AJHajh-20220125-ArunCrem Planning Response_LPA.docx

Y/184/21/DOC – CONDITIONS 8, 9 AND 10: DRAINAGE RESPONSE

Thank you for returning comments from your Drainage Engineer pertaining to planning conditions 8, 9 and 10 under planning permission Y/184/21/DOC for the Crematorium, Bognor.

Project No.	Originator	Volume	Lvl/Loc	Type	Role	Number	Rev
13591	CRH	ZZ	XX	DR	C	5200	P3

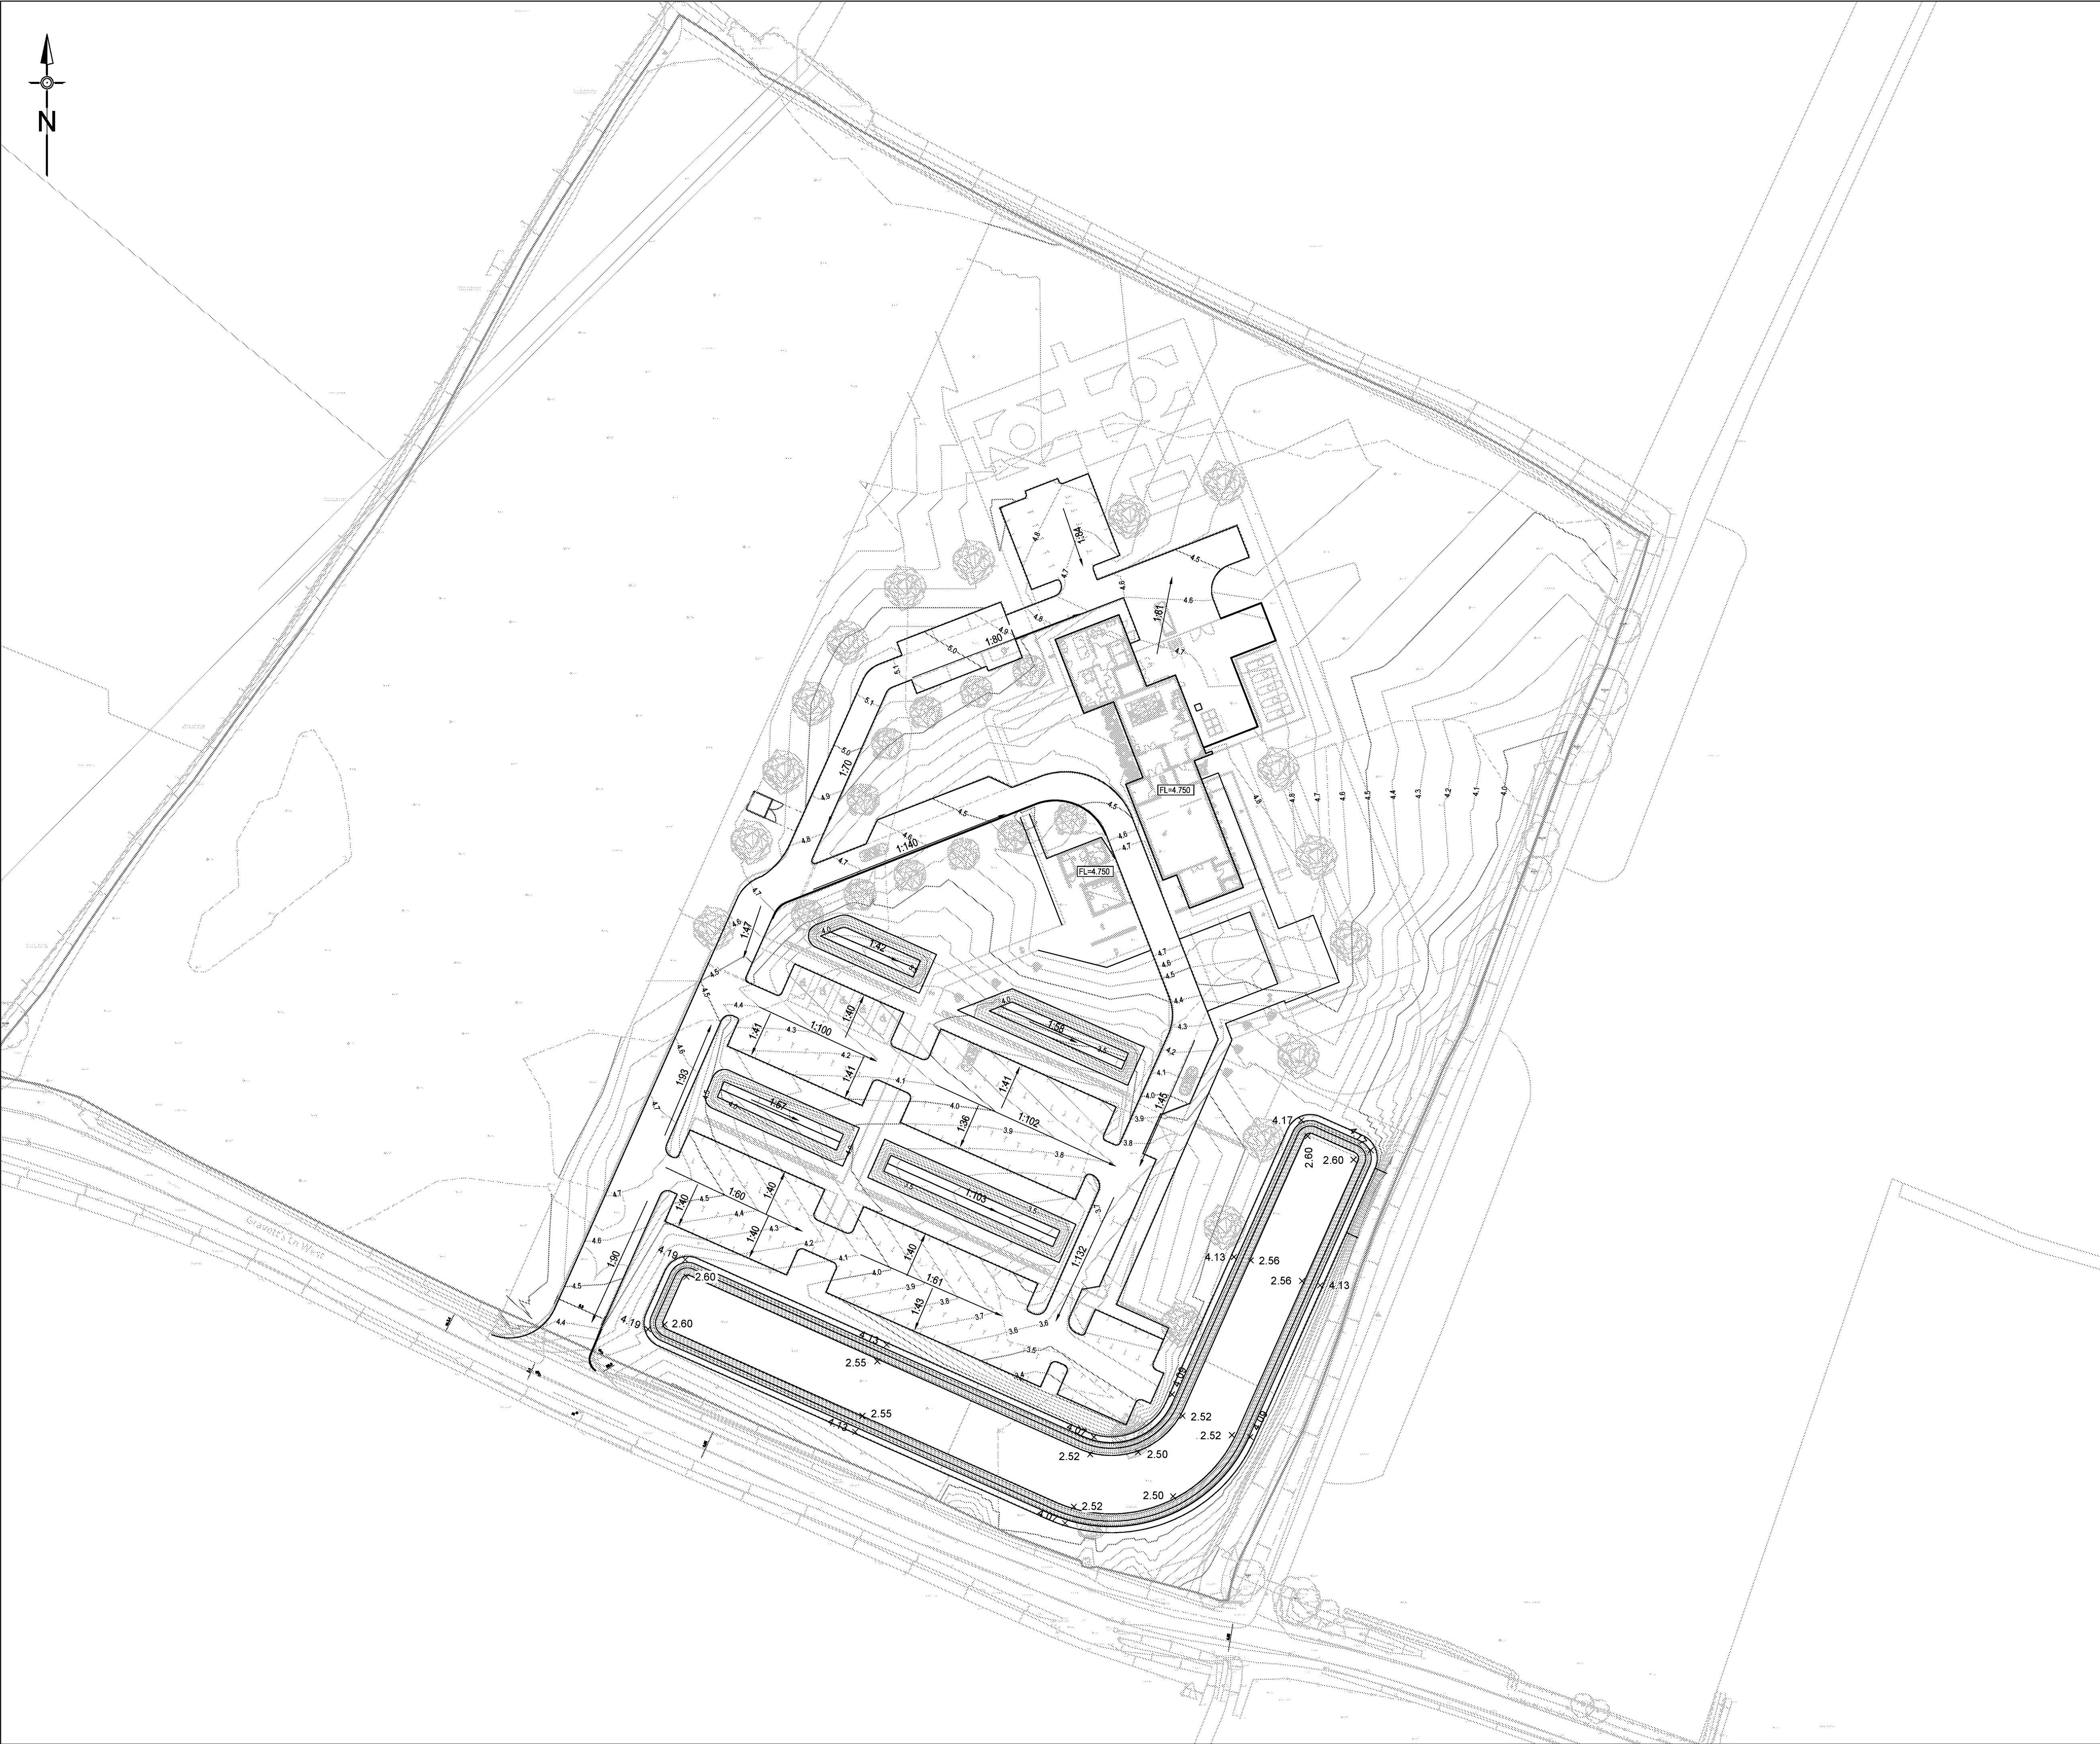
- 1. Please supply results of winter groundwater monitoring and winter infiltration testing.*
- 2. Please supply calculations to support design.*
- 3. Please supply an impermeable area catchment plan.*
- 4. Please label all pipes with diameter and fall.*
- 5. Hydrobrake unit references should be included on layout plans.*
- 6. Please label finish and formation level of permeable paving.*
- 7. Gullies and channel drains should be labelled with cover levels.*
- 8. The gabion outfall construction detail drawing is unclear. Is it proposed to have buried pipes discharging to the basin?*

be obtained from levels plan *13591-CRH-XX-XX-DR-C-5200 Revision P3* and sub base levels inferred (Minor updates to Revision P3 enclosed for completeness).

P3	Updated to suit planning comments.	25/01/22	AJH
P2	Updated to suit site layout. Issued for tender	24/11/21	JA
P1	Issued for Information	04/08/21	MW
Rev	Description	Date	By
